Name of Dam: Lake Heritage Dam

Inventory Number: VA 03332

PHASE I INSPECTION REPORT NATIONAL DAM SAFETY PROGRAM.

MICHAEL BAKER, JR., INC.

PLATE 1

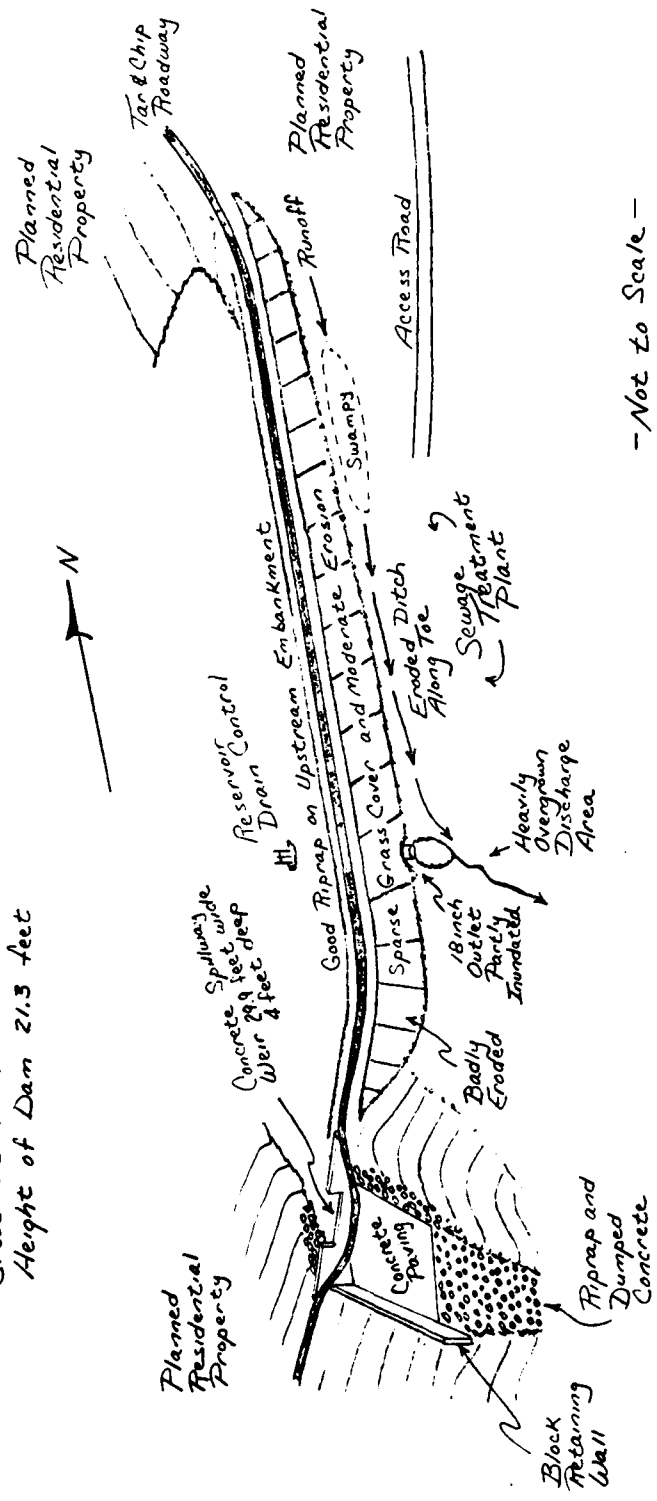
Signs of instability in the embankment such as slumping, tension cracks, or unusual alignment along the crest were not observed during the visual inspection. The lower section of the downstream embankment was generally dry even though an internal drainage system was not provided. No seepage through the embankment or along the toe of the dam was observed. The entire downstream embankment (particularly the right side) is sparsely vegetated and moderately eroded. The toe of the downstream embankment near the center of the dam has been eroded slightly by local runoff that is channeled between the dam and the sewage treatment plant that is situated immediately downstream of the dam (see Plate 1 and Photo 7). The channel is a few feet deep locally.
